REMARKS

By this Amendment, claims 1, 2, 4, 5, 9, 10, 12-15, 17 and 18 have been amended. Thus, claims 1-18 remain pending in the present application.

FIG.4

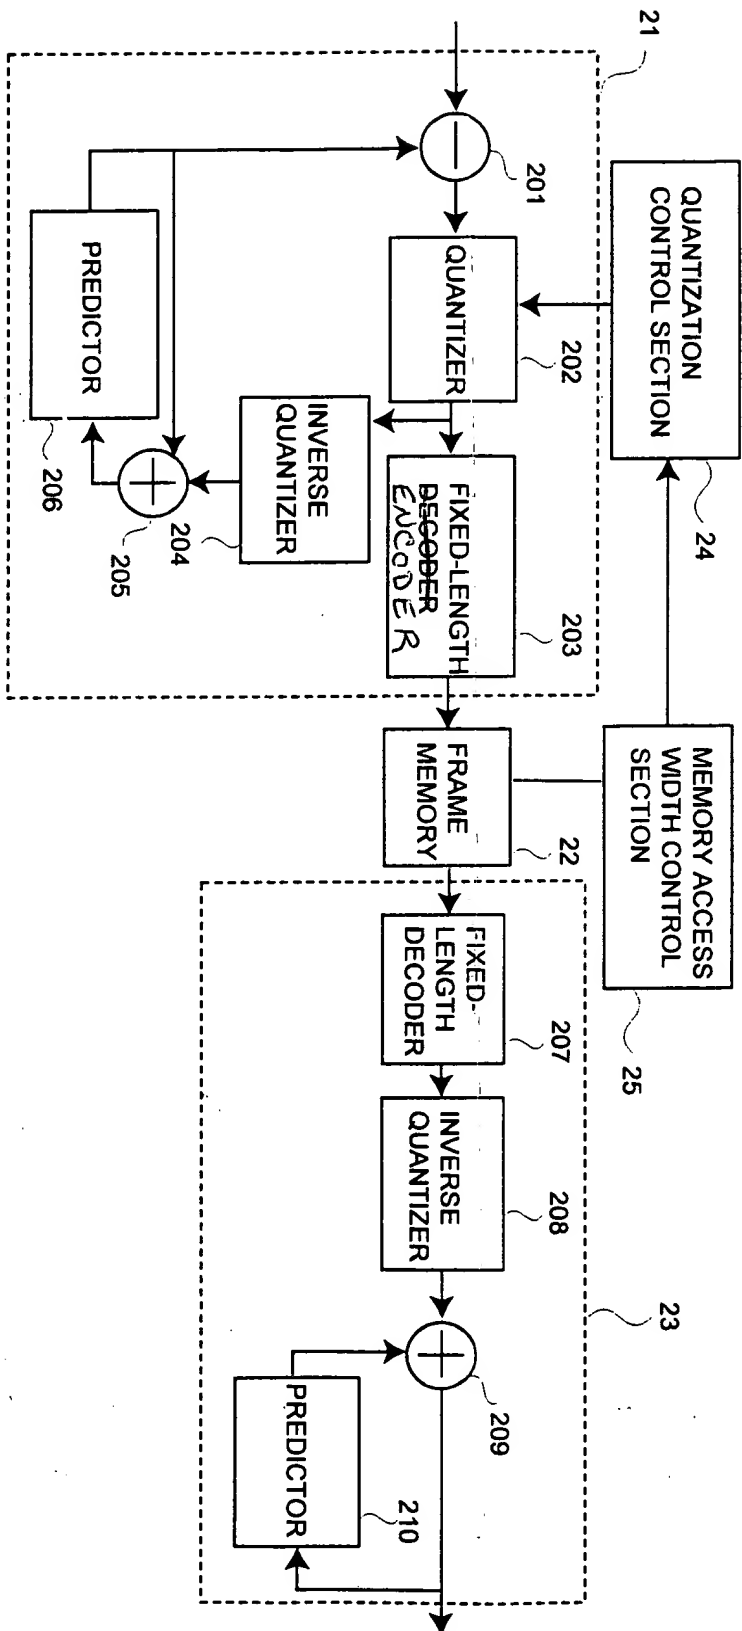
Fig. 4 has been amended to change Fixed-Length Decoder 203 to Fixed-Length Encoder 203 in accordance with the Examiner's suggestion in item 2 of the Office Action. It is also proposed to amend the figure by adding a line directly connecting the Memory Access Width Control Section 25 and the Frame Memory 22, generally corresponding to the line connecting the Frame Memory 106 with Access Width Control Section 110 in Figures 1 and 5. Approval of the drawing change is therefore respectfully requested.

Approved
6/18/02
